Preliminary Consultation
MONTGOMERY COUNTY HISTORIC PRESERVATION COMMISSION
STAFF REPORT

Address:	6100 Connecticut Avenue, Chevy Chase	Meeting Date:	3/22/2023
Resource:	Outstanding Resource Chevy Chase Village Historic District	Report Date:	3/15/2023
Applicant:	Chevy Chase Country Club (DLR Group & EHT Traceries)	Public Notice:	3/8/2023
Review:	Preliminary Consultation	Tax Credit:	N/A
		Staff:	John Liebertz

PROPOSAL: Chevy Chase Club fenestration alterations, construction of new terrace, hardscape and pathway alterations, terrace alterations, installation of cable railings, new rooftop mechanical equipment, tree removal, and lighting alterations.

NORTH ELEVATION PROPOSED NEW WINDOW

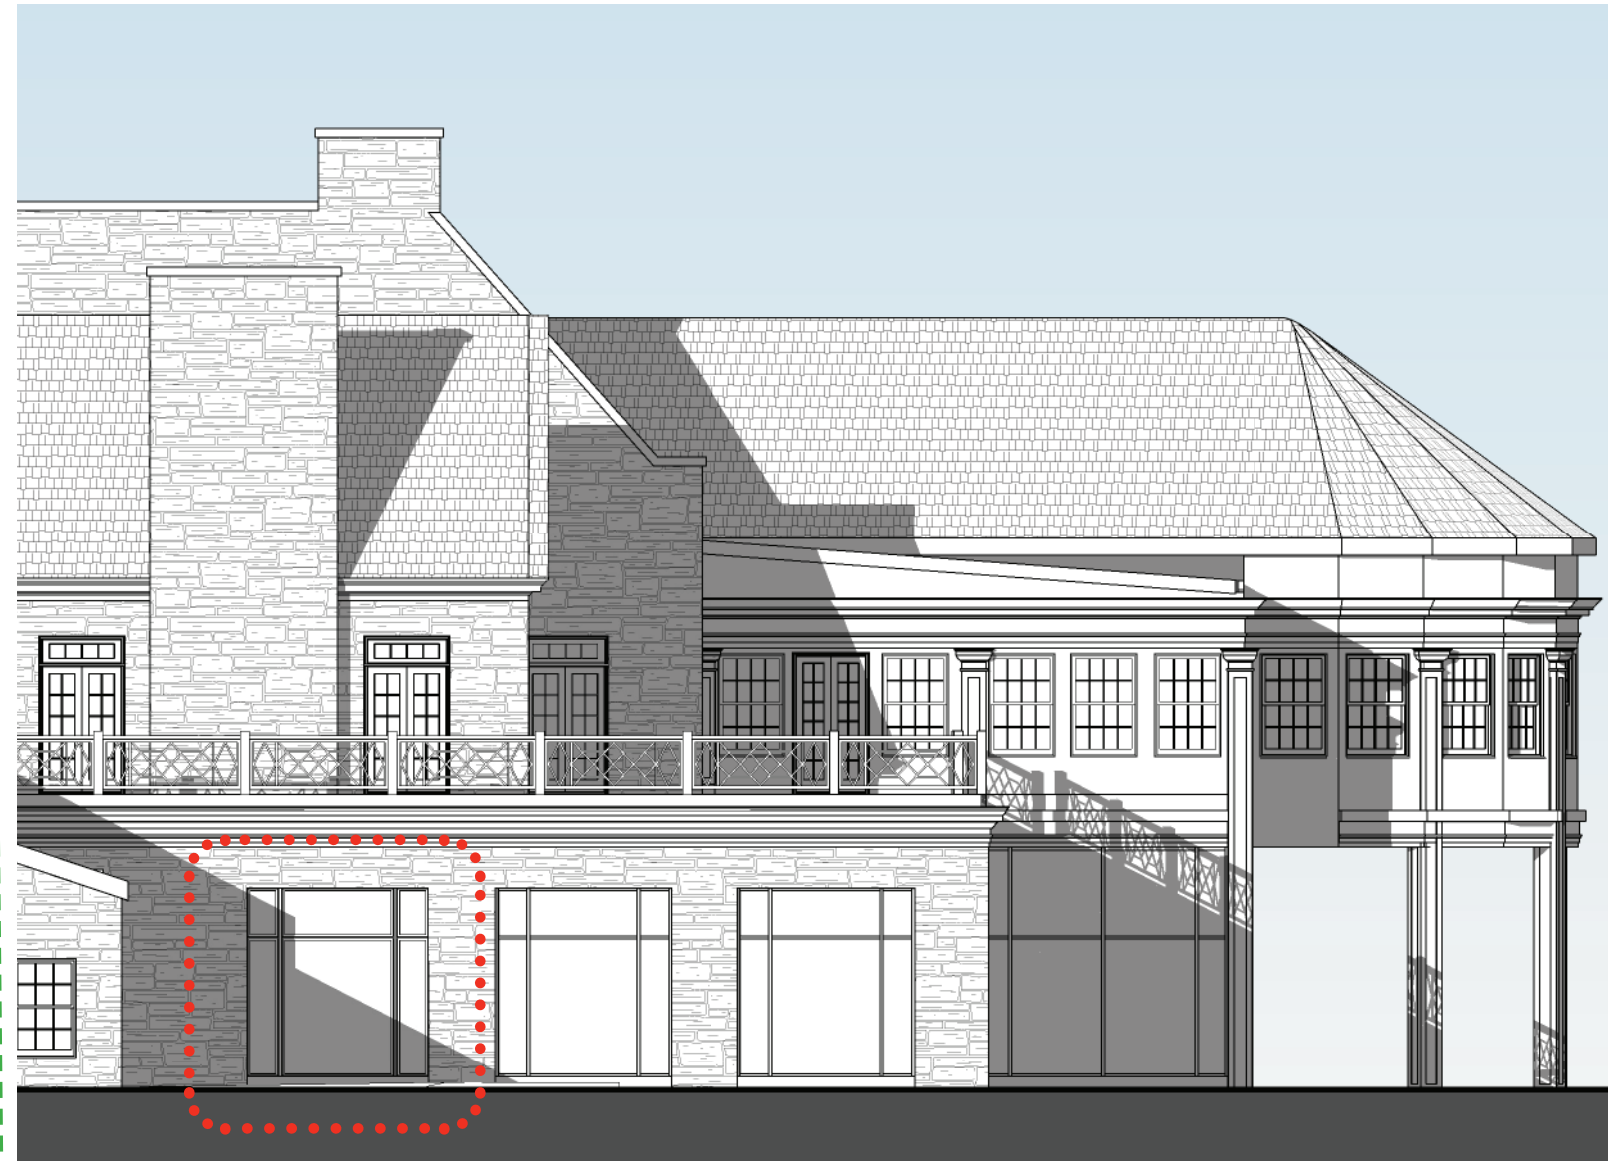
The applicant proposes to remove a multi-leaf, automatic, sliding glass door and restore the opening to its original condition. The proposed window would match the two existing windows to the north, is compatible with the design and fenestration patterns of the clubhouse, and should be approved as a matter of course as it is on the rear elevation. Future HAWP applications should include all specification sheets and affirm that the window is constructed of wood.
